To: Oregon Energy Facility Siting Council

Subject: Agenda Item B (Action Item) - Golden Hills Wind Project - Council Review of Requests for Contested Case on Proposed Order on Request for Amendment 5; and Proposed Order on Request for Amendment 5 for the October 25-26, 2018 EFSC Meeting

Attachments: Attachment 1: Proposed Order on Request for Amendment 5 (red-line version)

1 **Figure 1: Facility Location**

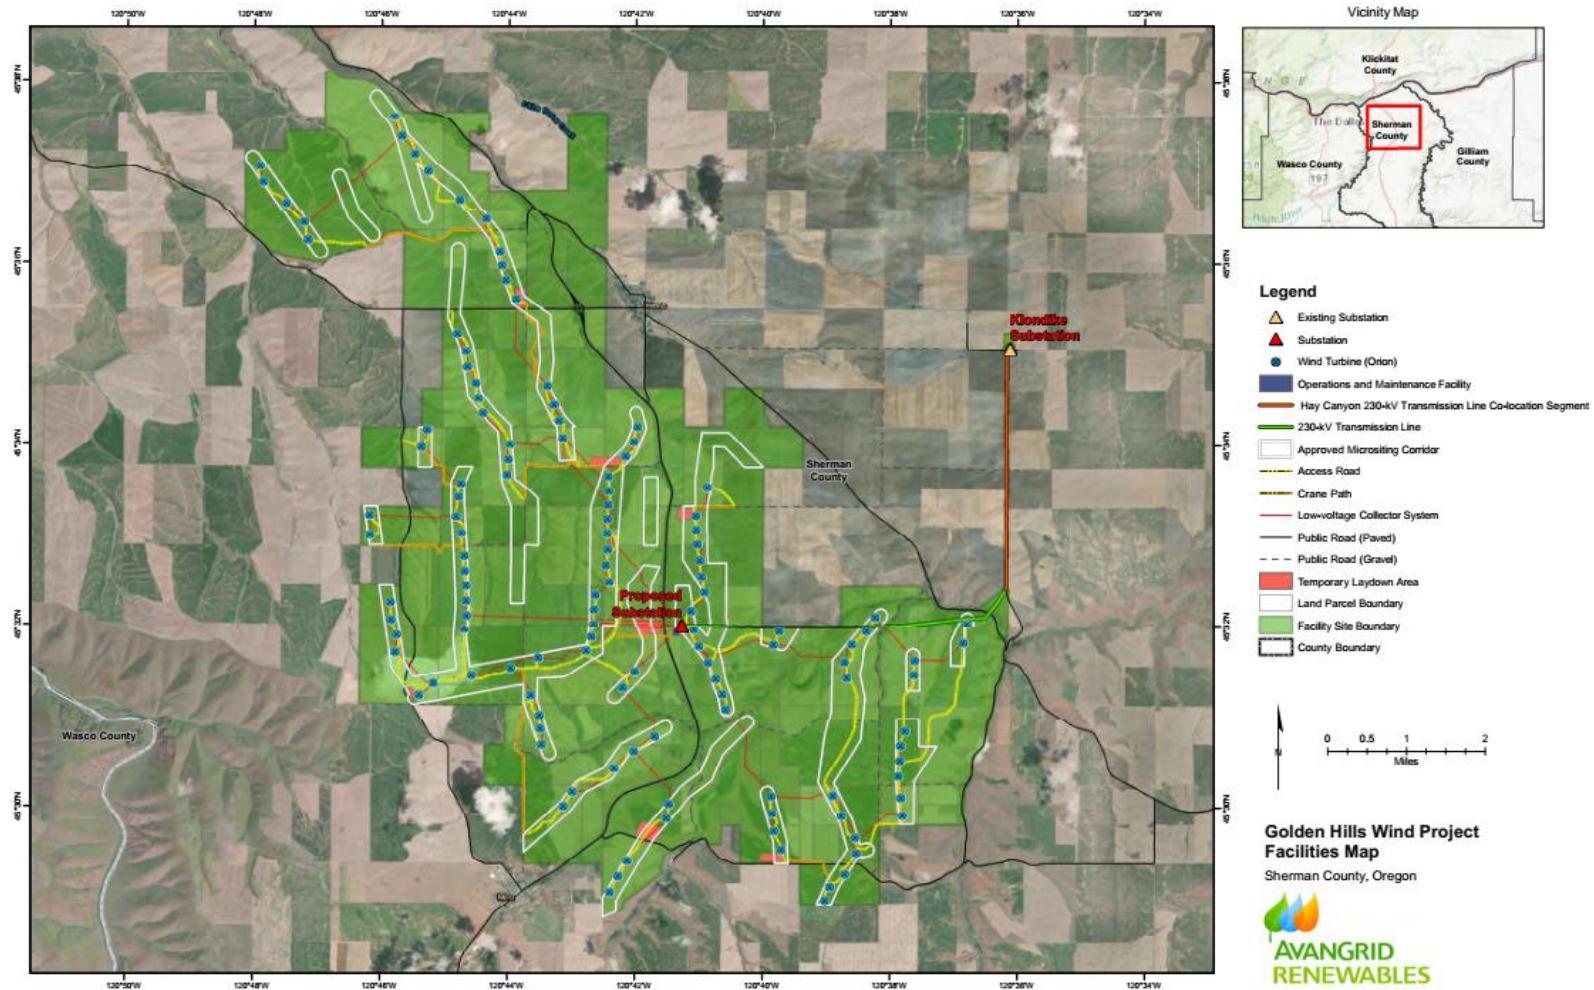
29
30
⁴ On the record of the draft proposed order, the certificate holder notified the Department that Figure 1 of the draft proposed order did not accurately represent the previously approved Hay Canyon 230 kV transmission line co-location segment and site boundary area around the Klondike Substation. Based on this comment, the Department updates Figure 1 from the draft proposed order to proposed order.
